# RECORD OF DECISION

Northrop Grumman - Bethpage Facility  
Operable Unit Number: 03  
State Superfund Project  
Bethpage, Nassau County  
Site No. 130003A  
March 2013

Prepared by  
Division of Environmental Remediation  
New York State Department of Environmental Conservation

**Figure 10**  
**Offsite Groundwater Conceptual Remedy**  
**Total Volatile Organic Compounds**  
**Former Grumman Settling Ponds**  
**Town of Oyster Bay, Nassau County**  
**NYSDEC Site No. 130003A-OU3**

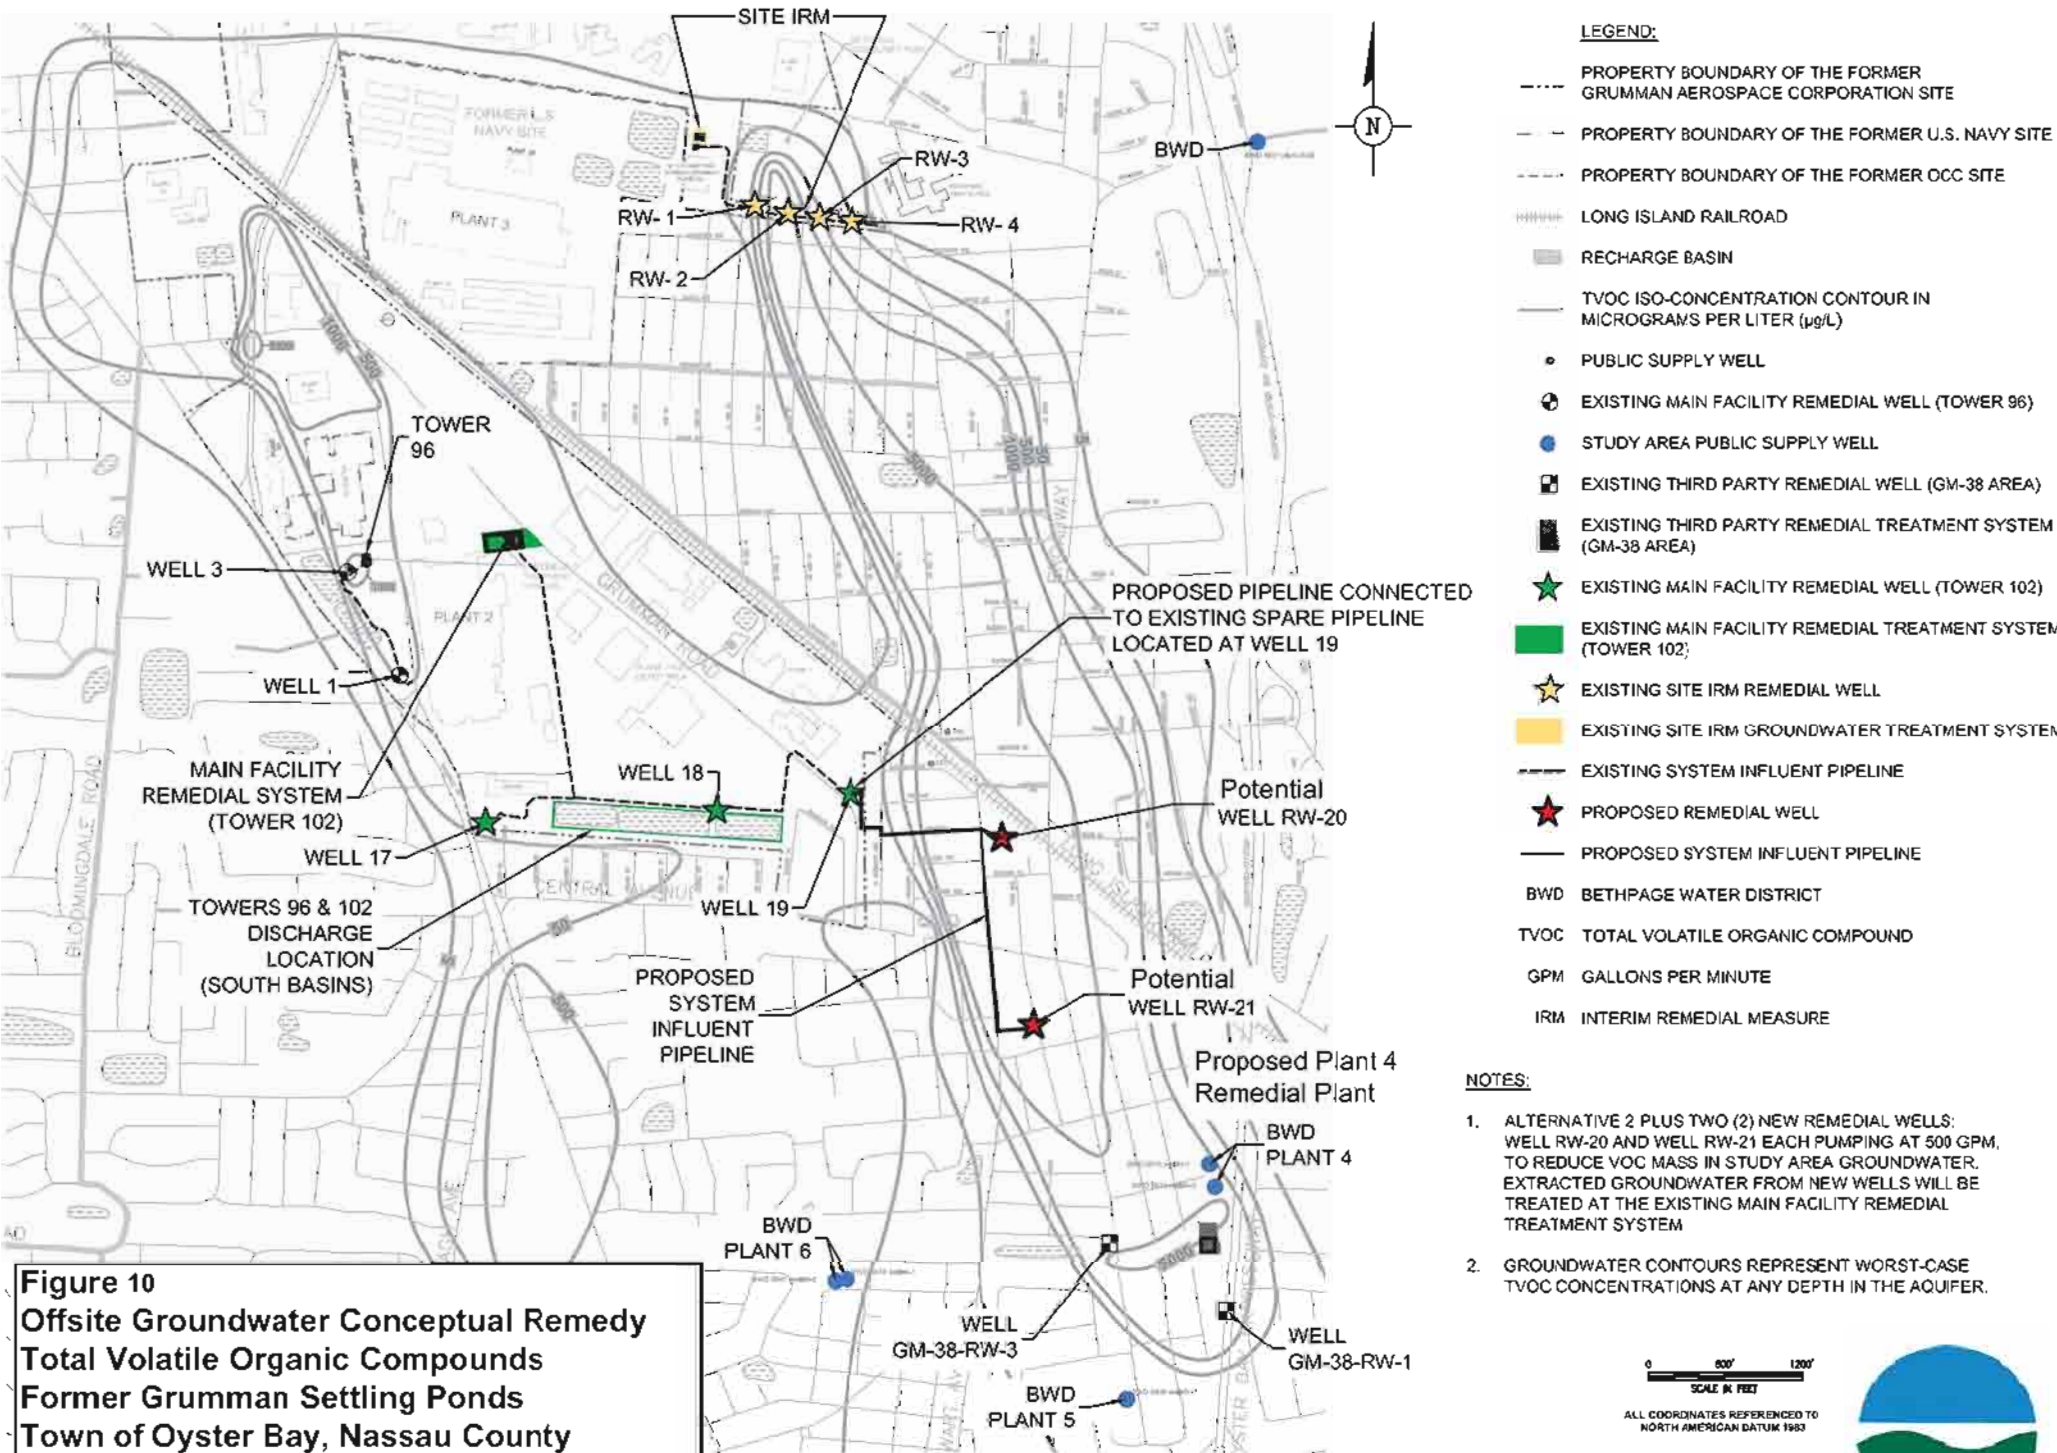
**Comment 143:** Figure 10: The width of the groundwater plume is about 1,000 feet. It appears feasible to install a series of wells to provide hydraulic control of the OU 3 plume near its leading edge and upgradient of Bethpage Plant 4. Hydraulic control will maximize plume capture and remediation over time.
